House 28' x 20'
Island Avenue
Cliff Island
Maine

CITY OF PORTLAND, MAINE
SITE PLAN REVIEW
 Processing Form

BUILDING DEPARTMENT SITE PLAN REVIEW
 (Does not include review of construction plans)

House 28' x 20'
Island Avenue
Cliff Island
Maine

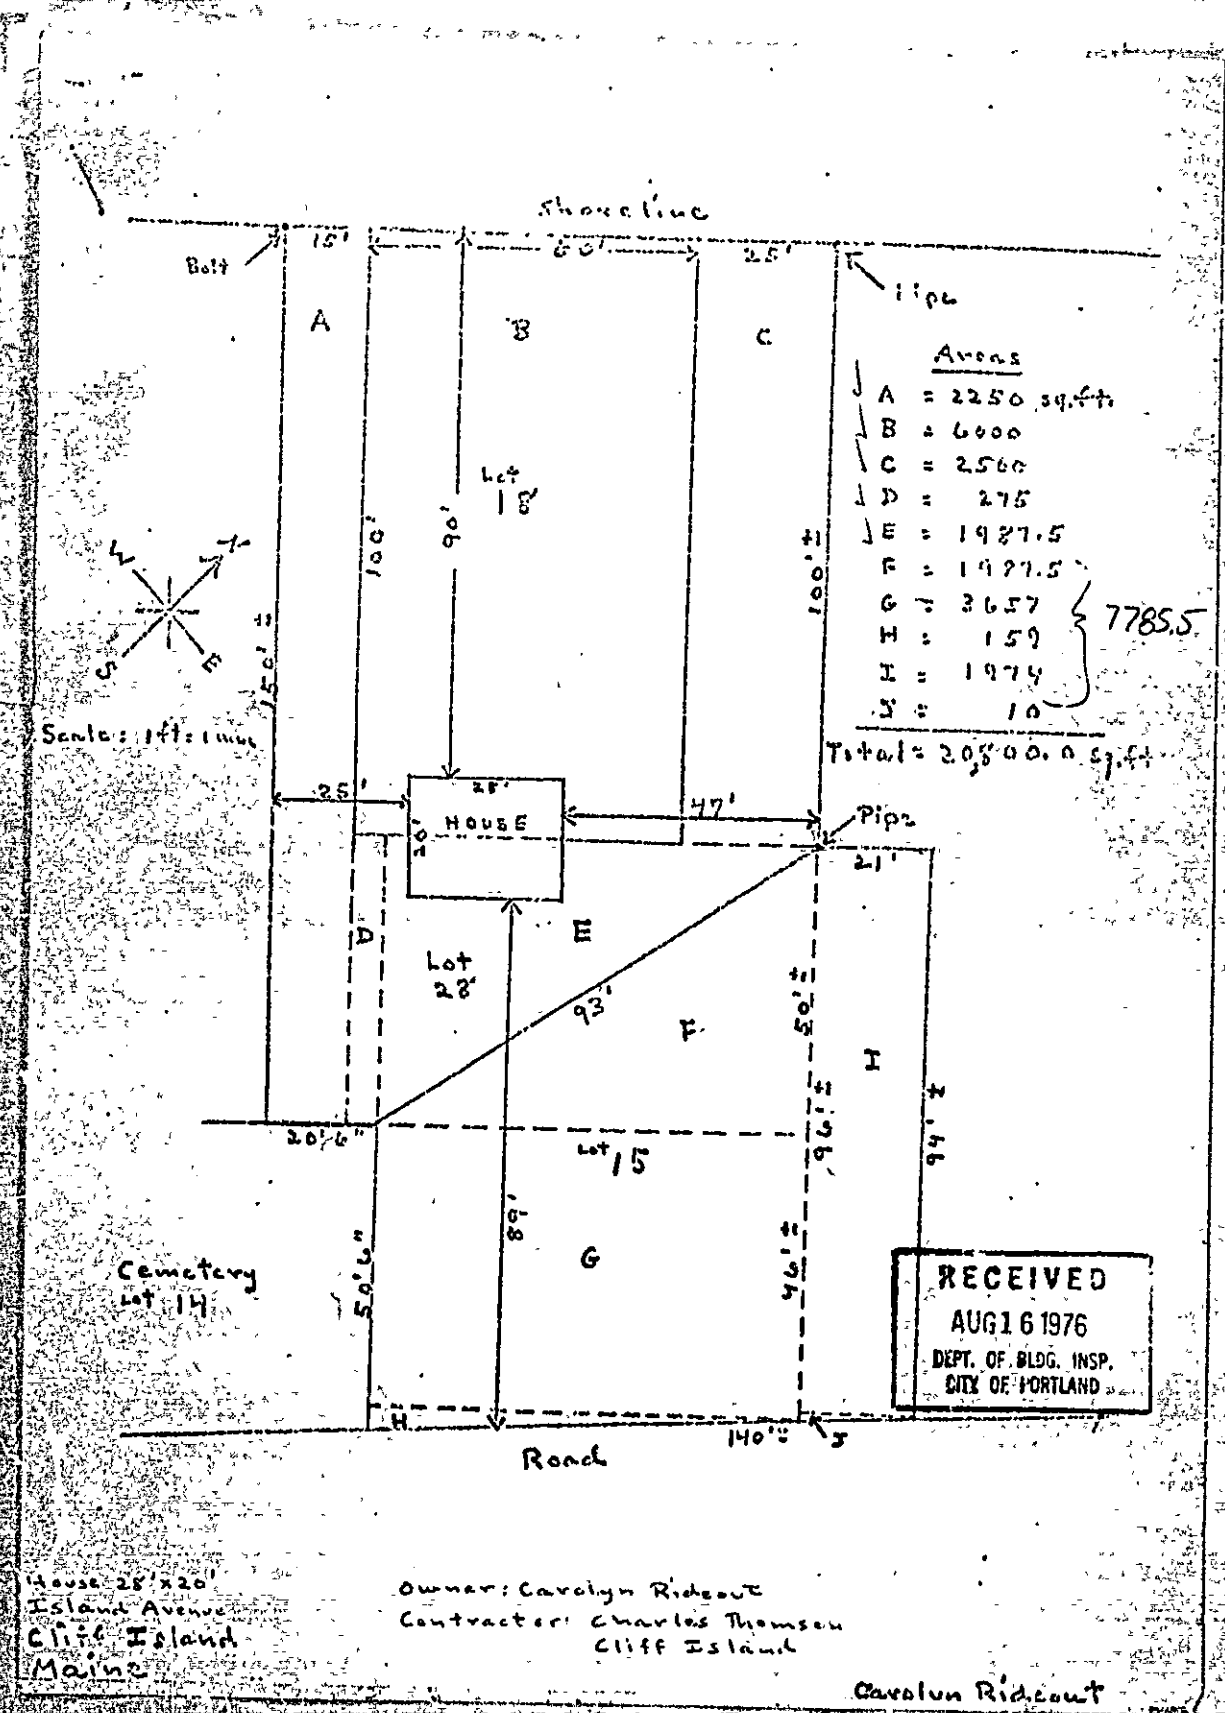
REASONS: The Building Department should document that the applicant has title to land in excess of 20,000 sq ft to be in compliance with Title 12, Sections 480 and 480A, the Minimum Lot Size Law.
 The latest information regarding flood prone land shows that the property in question is flood prone up to 50 feet from the shoreline; therefore, the proposed structure should not be affected by flooding.
